DRB PROJECT NO. 1000301/02DRB-00404

AMENDMENT #2

SUNRISE RANCH SUBDIVISION
SITE DEVELOPMENT / LANDSCAPE PLAN

PURPOSE FOR AMENDMENT #2

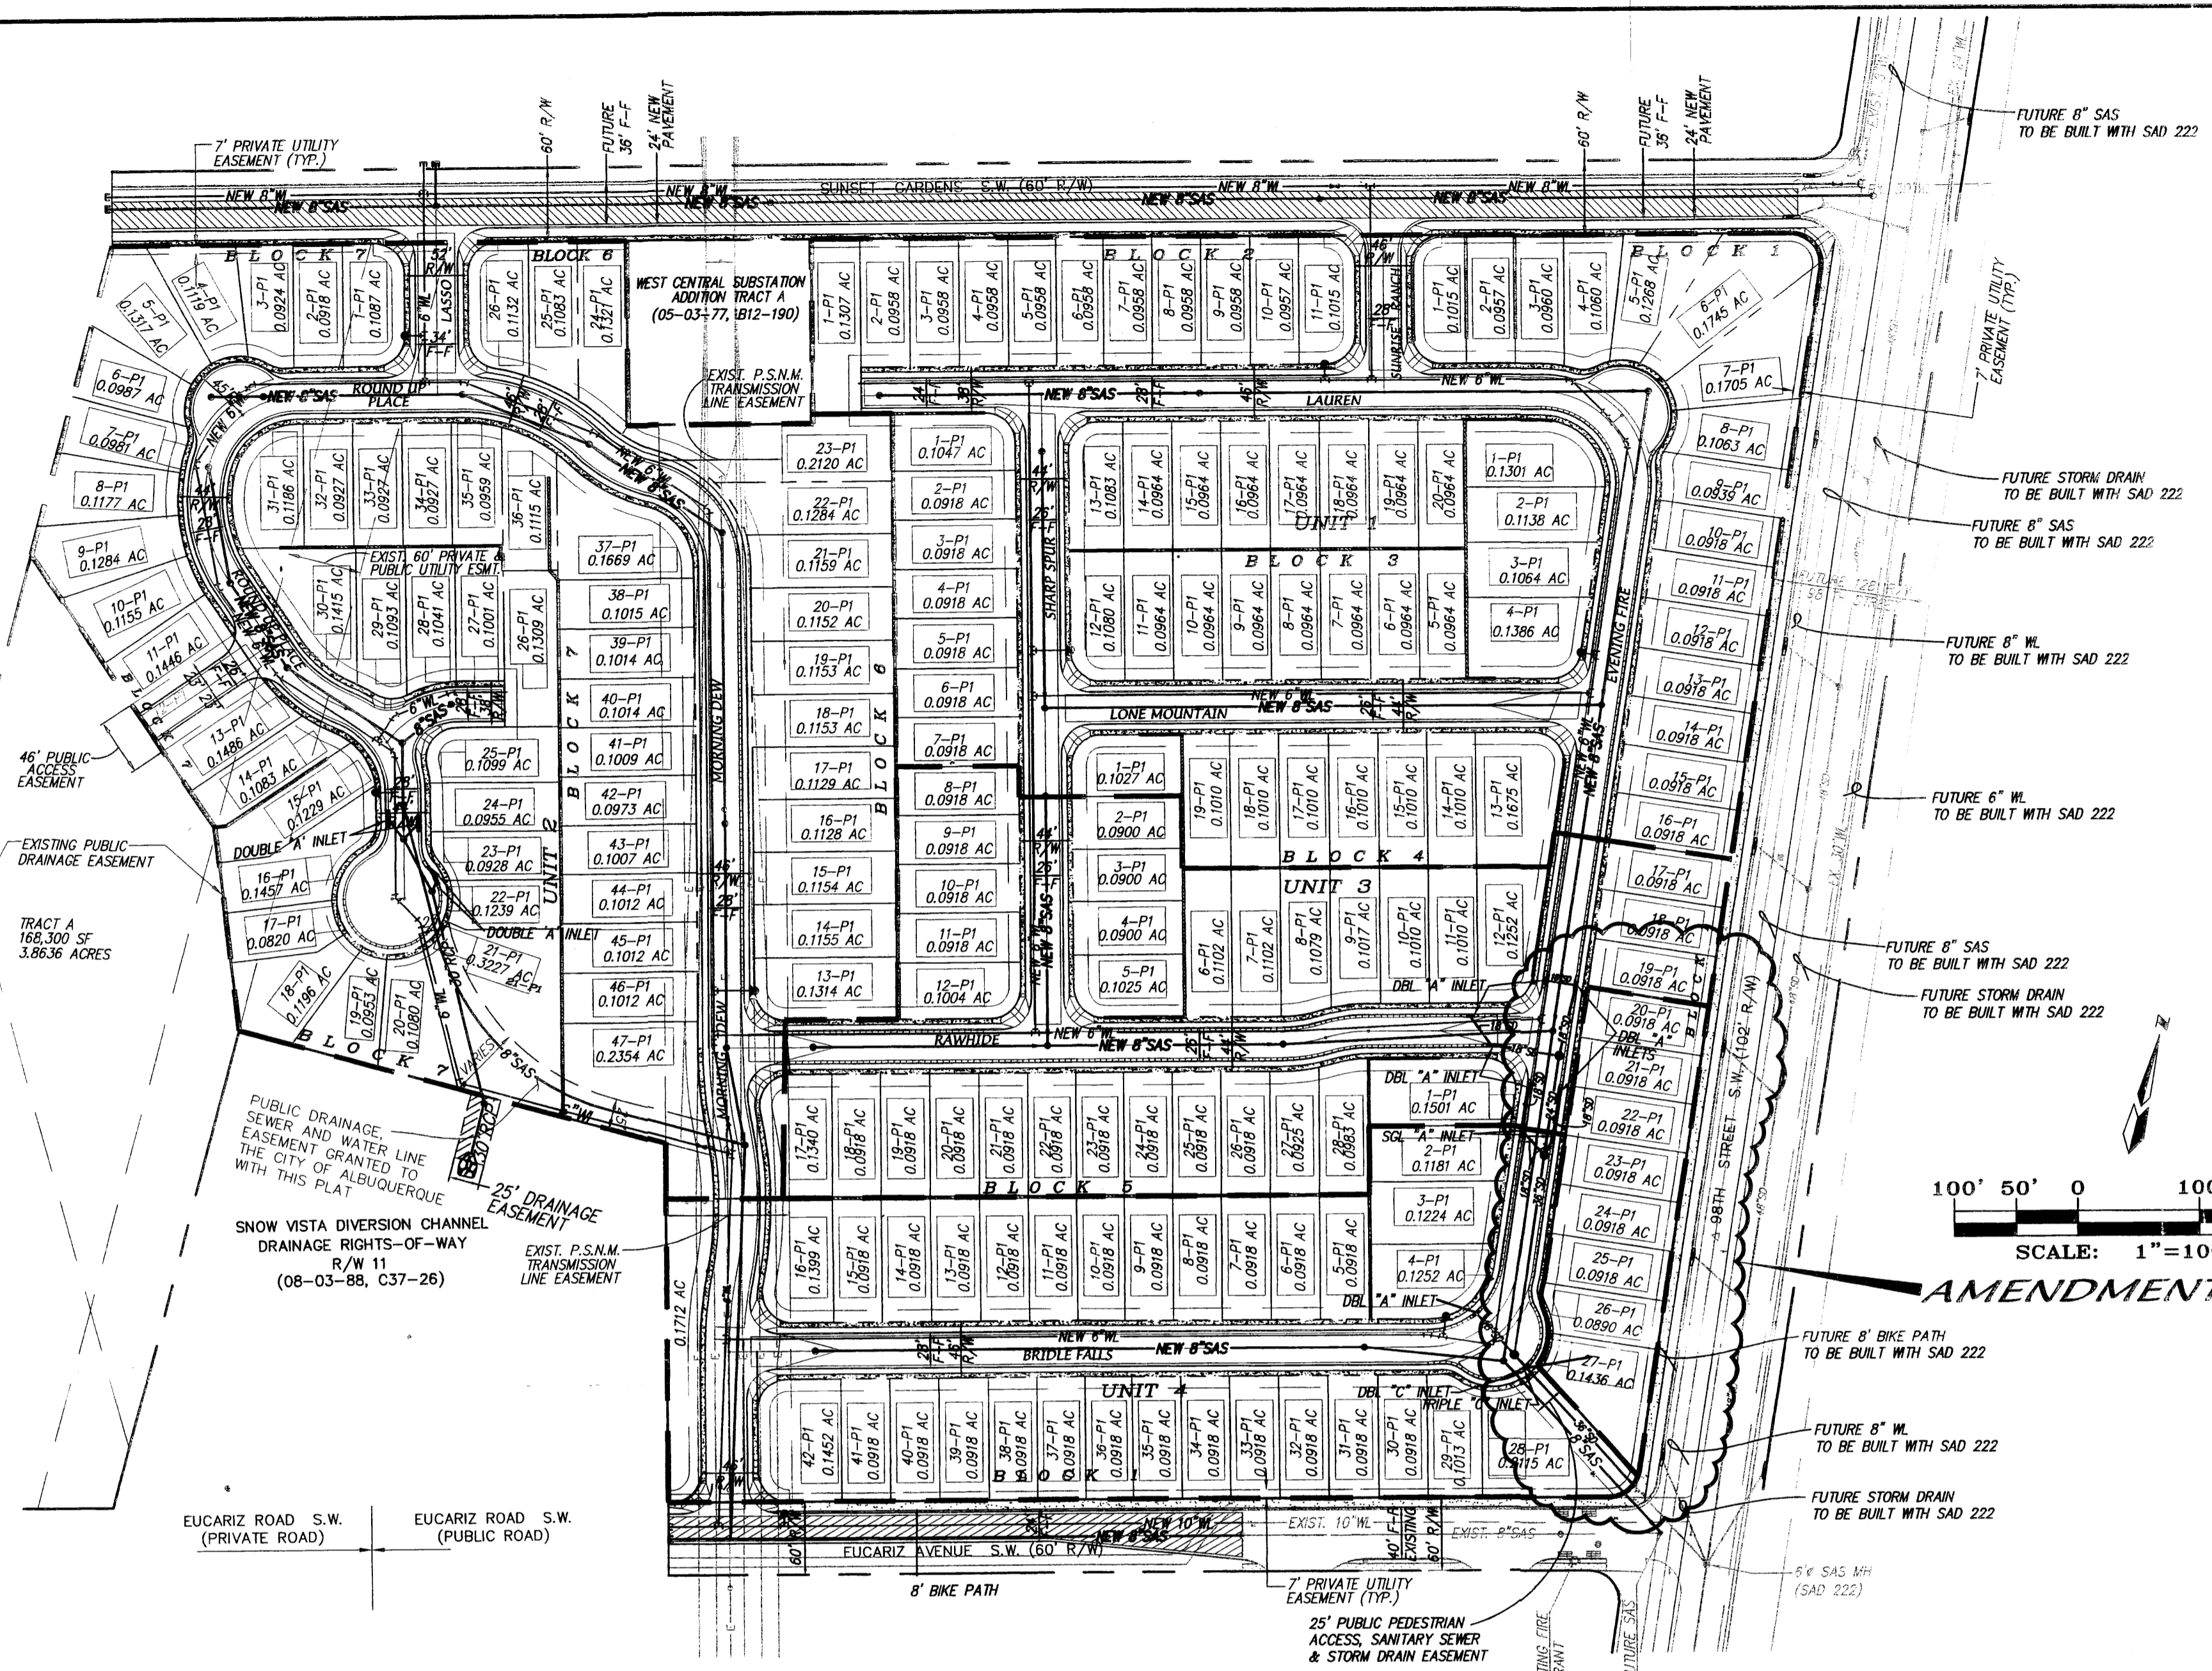
THE SAD 222 STORM DRAIN IN 98TH STREET HAS BEEN ACCEPTED BY THE CITY. AS A RESULT, WE ARE PROPOSING TO FILL THE RETENTION POND, REROUTE THE STORM FLOW TO THE STORM DRAIN IN 98TH STREET, AND DEVELOP THE LOTS.
